Model: HCD-S300, DAV-S300

No. 687R1

Subject: New and old board compatibility (Power & Audio)

Date: December 10, 2001

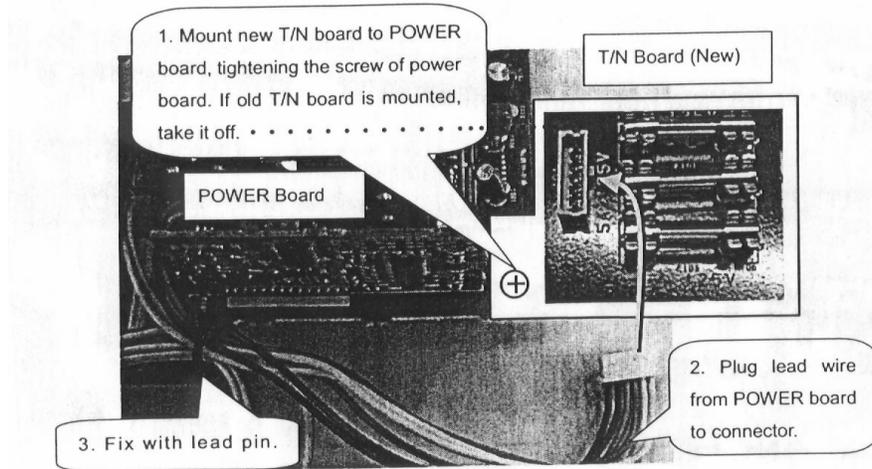
The Power and Audio boards were changed halfway through manufacturing. Please refer to the following procedures for compatibility.

Combination of new POWER Board and old Audio Board. 1. Mount the new T/N board to the POWER Board using one screw of the POWER Board. If old T/N board is mounted to POWER Board, remove it. 2. Plug the lead wire from the POWER Board to the connector of the T/N Board. 3. Secure the lead wire using the lead pin.

Combination of Old POWER Board (1-676-632-11) and new AUDIO Board (1-680-861-12) 1. Cut pattern of old POWER Board (See HiFi Bulletin 651R1 for details). 2. Route lead wire (A-4735-718-A) as below. 3. Fix lead wire with glue (SC-608LV: 7-432-912-48), tape (7-632-661-00) as described below. Plug lead wire into the connector of the T/N board.
